## **MEETING NOTICE**

A meeting of the  
**Bayside Local Planning Panel**  
will be held in the Committee Room, Botany Town Hall  
Corner of Edward Street and Botany Road, Botany  
on **Tuesday 22 October 2019 at 6:00 pm.**

6.1	DA-2015/10216/G - 8 Galloway Street, Mascot .....	12
6.2	DA-2019/160 - 10/30 Stephen Road, Botany.....	80
6.3	DA-2018/378 - 13A-17 Swinbourne Street, Botany .....	124
6.4	DA-2018/368 - 1449 Botany Road, Botany .....	275

Figure 1: Rooftop plan extract

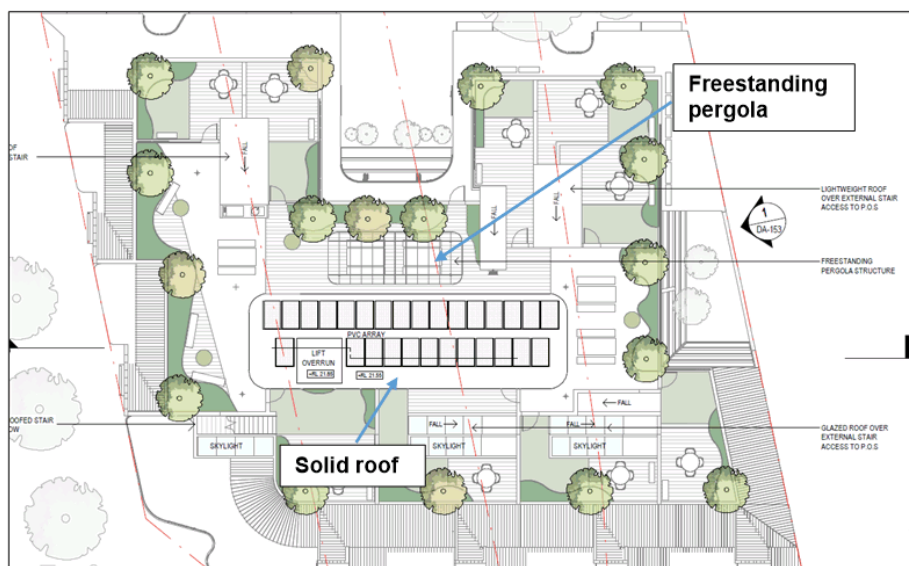
The extent of solid roof proposed over the communal open space area has been substantially reduced. A small, lightweight free standing pergola has been introduced in the centre of the communal open space area. Refer to Figure 1 below which identifies the roof elements:

As identified in **Figure 1**, there is a solid roof proposed over a portion of the communal open space area which will provide weather protection. Whilst the roof is not a light weight structure, the size of it has been substantially reduced to ameliorate the concerns raised with respect to visual bulk and scale. A small, lightweight free standing pergola has been introduced in the centre of the communal open space area

Figure 6: 12m height plane diagram. Approved development at 23 Swinbourne St also shown which does not comply with the height development standard.

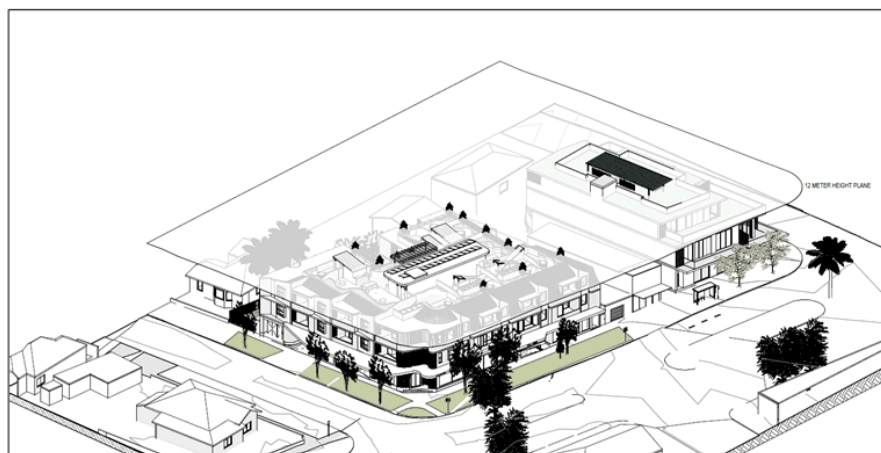
As can be seen from Figures 4 - 6 above, the non-compliant building elements relate to the pergola structure/WC within the rooftop communal area, the roofs over the northern private open space areas and the lift overrun/fire stairs.

Figure 11: Approved Section – 23 Swinbourne Street

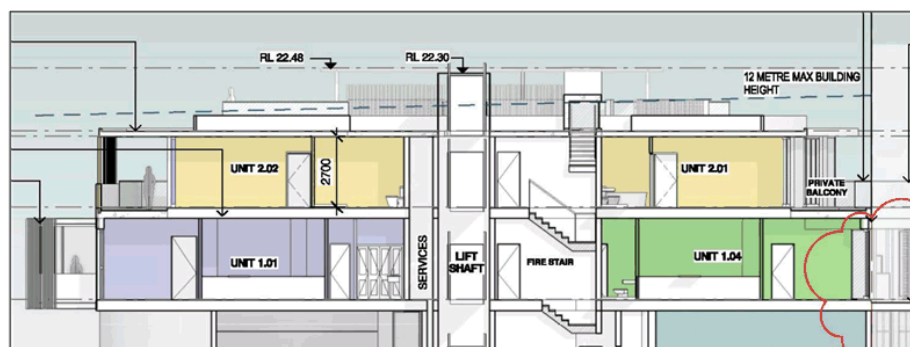
**Officer Comment:** It is noted that a similar height non-compliance has been approved at No.23 Swinbourne Street, east of the subject site. This application was approved at the Bayside Local Planning Panel meeting on 28 November 2017. The extent of the height breach on that site was 1.55m or 12.9%. Refer to approved plan extract below:

Figure 10: 12m height plane diagram. Approved development at No.23 Swinbourne Street also shown which does not comply with the height development standard.

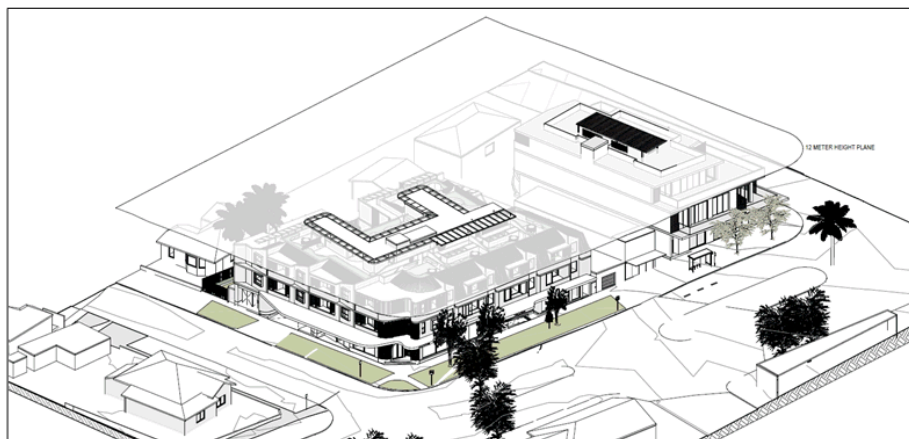
As can be seen from Figures 8 - 10 above, the non-compliant building elements relate to the pergola structure/WC within the rooftop communal area and the lift overrun/fire stairs.

Figure 11: Approved Section – 23 Swinbourne Street

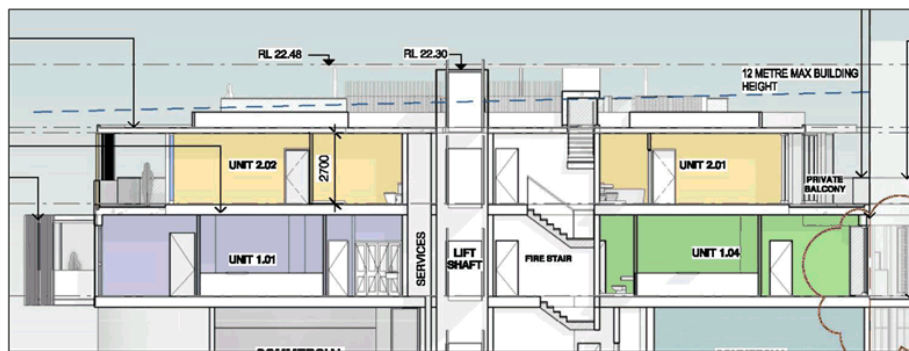
**Officer Comment:** It is noted that a similar height non-compliance has been approved at No.23 Swinbourne Street, east of the subject site. This application was approved at the Bayside Local Planning Panel meeting on 28 November 2017. The extent of the height breach on that site was 1.55m or 12.9%. Refer to approved plan extract below:

Figure 12 – Extract of Figure 20 in Part 5.2.2.5 of BBDCP 2013

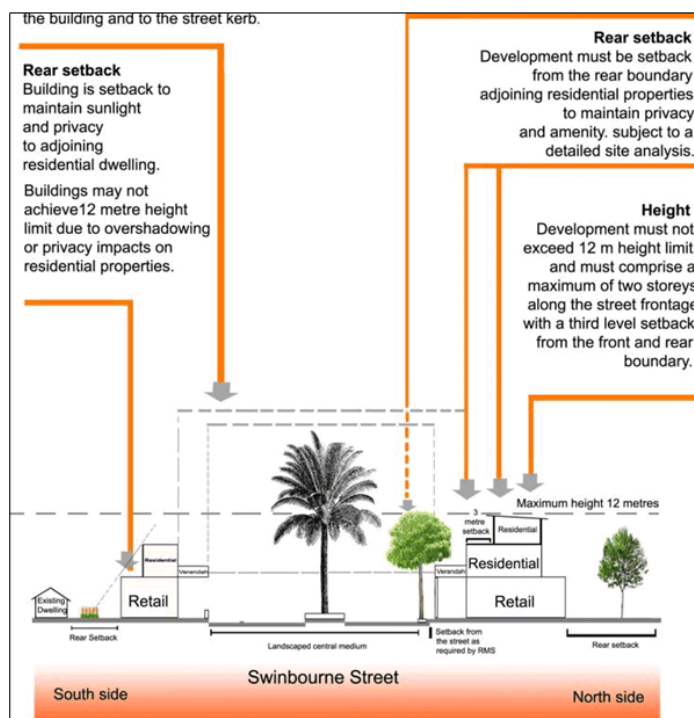
Figure 20 specifies a 3m front setback and restricts development to two (2) storeys along the street frontage. See below:

The proposed development encroaches into the 3m front setback area, however it utilises architectural design and elements to give the appearance of a greater setback, when viewed from the street. The following is noted in this regard:

Figure 8. Reproduction of Figure 24 from Part 5 of the BBDP 2013

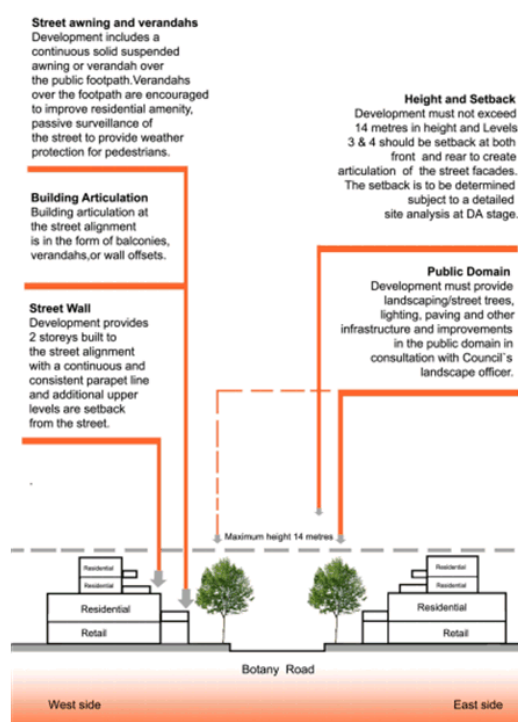
The proposed development seeks to provide a two storey street wall with the upper level (Level 2) setback 3.5 metres off the boundary. Figure 24 does not provide any dimensions regarding to the required setback of the upper levels however it is demonstrated that any storey that is located above the second level will need to set in the balconies as well as any built form away from the boundary to reduce the visible bulk perceived from the street. The applicant has demonstrated that their balconies for units on Level 2 are located on the boundary with the built form 3.5 metres from the boundary. This is not considered to be an appropriate setback from the street and still presents a significant bulk. The applicant has also designed their development on the basis that the adjoining development application that is currently under assessment on 1445 to 1447 Botany Road has been approved. This is not the case and should not be relied upon. The proposal also seeks to provide a consistent and transitional built form with the development to the south by aligning their parapet with the existing shopfront. The proposal also seeks to build to the southern boundary for the majority of the length. The applicant is anticipating that the adjoining development will be developed similarly to the subject proposal however by maintaining the existing parapet of the adjoining building, there are issues in compliance with ADG requirements such as ceiling height controls. Additionally, consideration of both the existing cottage on the site and the adjoining sites as contributory items have not been considered by the applicant.
